SUBJECT: ISSUANCE OF ORDER MODIFYING LICENSE NO. R-125 TO CONVERT FROM  
HIGH- TO LOW-ENRICHED URANIUM (AMENDMENT NO. 12) - UNIVERSITY OF  
MASSACHUSETTS LOWELL (TAC NO. M86788)

ORDER MODIFYING FACILITY OPERATING LICENSE NO. R-125

ENCLOSURE TO LICENSE AMENDMENT NO. 12

REPLACEMENT PAGES FOR TECHNICAL SPECIFICATIONS

Figure 2.1 T.S. Power-Flow Safety Limit Curve

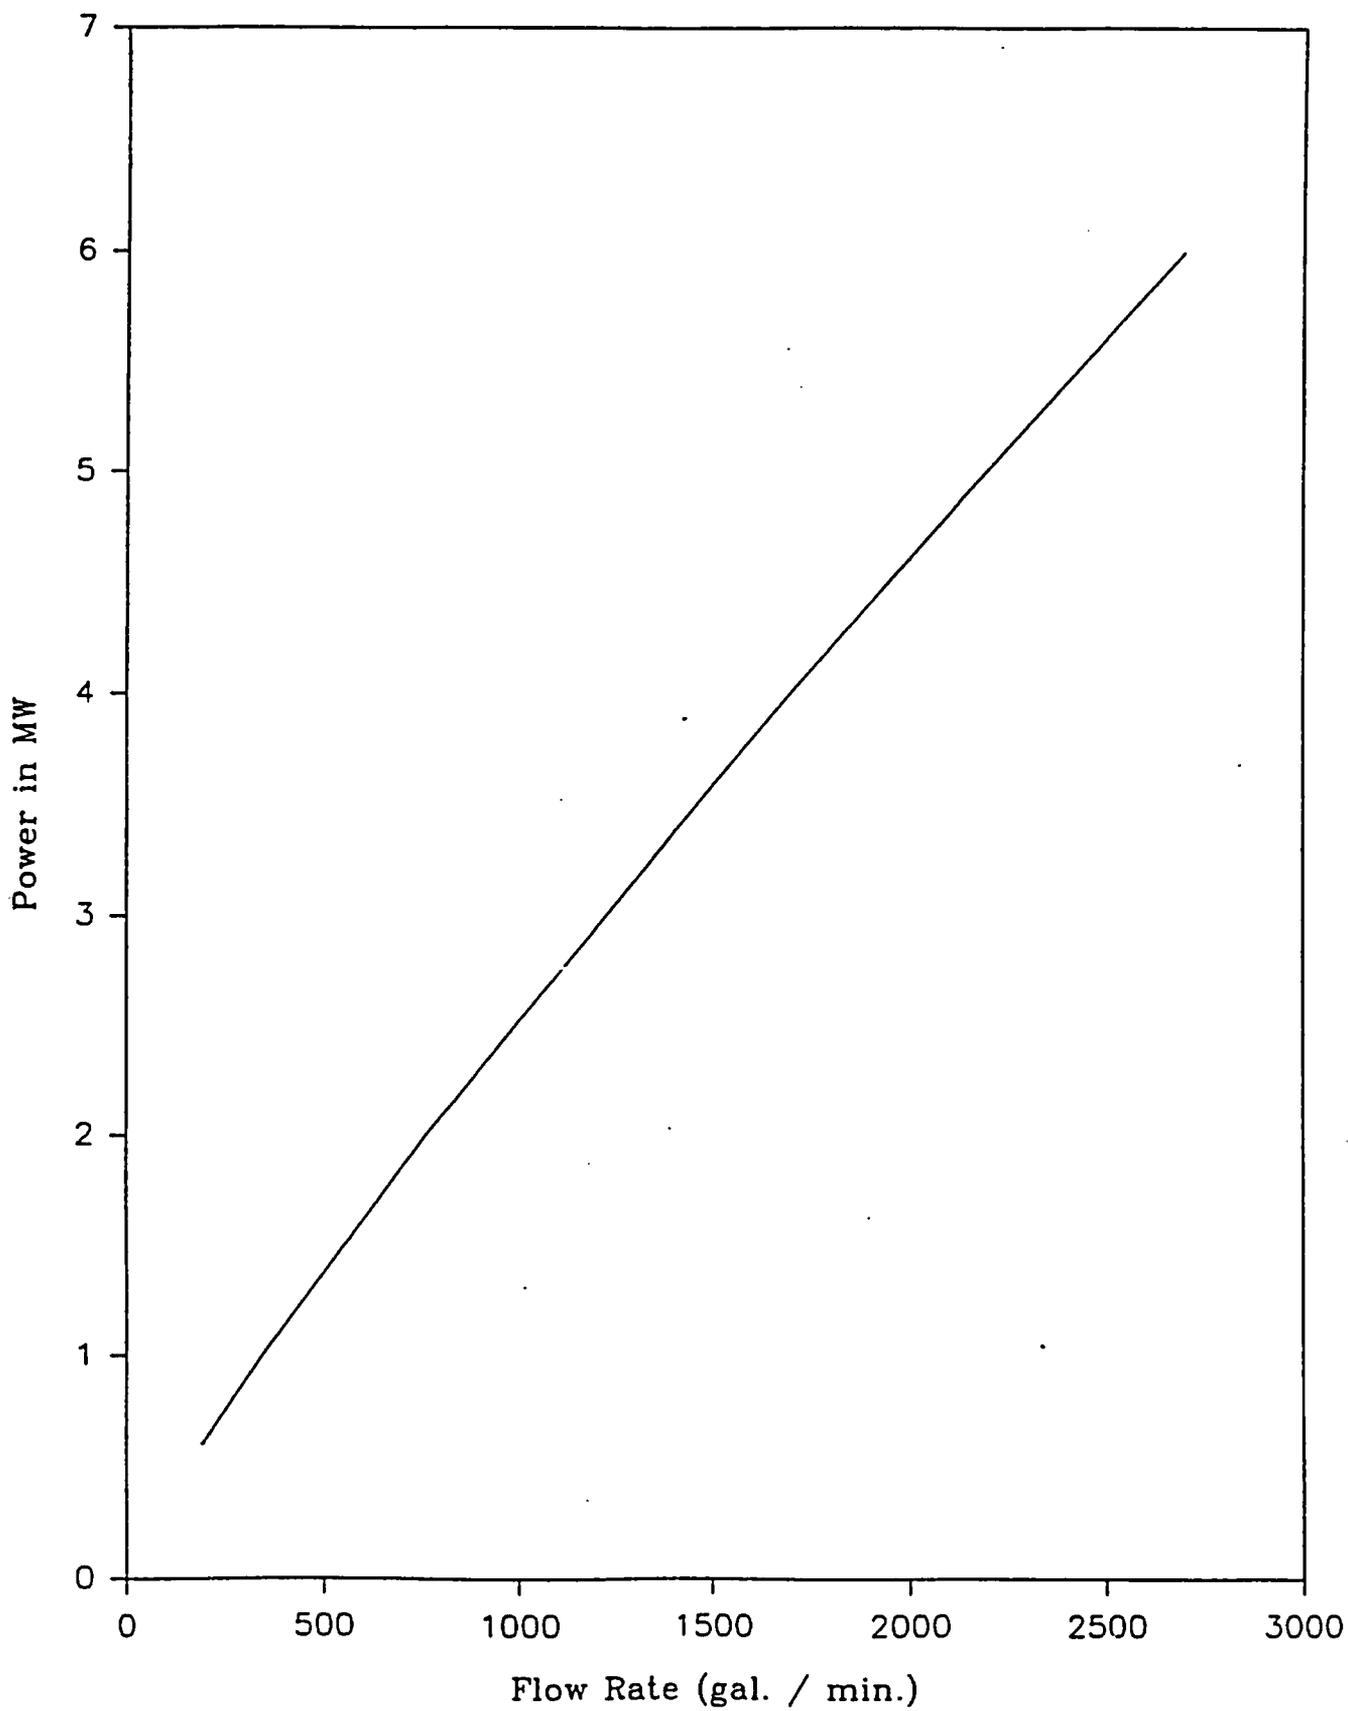
The licensee proposed to change the safety limits for forced flow and add Figure 2.1, which will replace existing TSs 2.1.1.1 and 2.1.1.2. Figure 2.1 represents the relationship between reactor thermal power and reactor coolant flow rate and indicates the flow necessary to prevent ONB for a given power level. Since Figure 2.1 is a more comprehensive way of indicating this safety limit, the staff finds this TS change acceptable.

1. The combination of true values of reactor thermal power (P) and reactor coolant flow rate (W) shall not exceed the limits shown in Figure 2.1 T.S under any operating conditions. The limits are considered exceeded if the point defined by the true values of P and W is at any time above the curve shown in Figure 2.1 T.S.
2. The true value of the pool water level (L) shall not be less than 24 feet above the center line of the core.
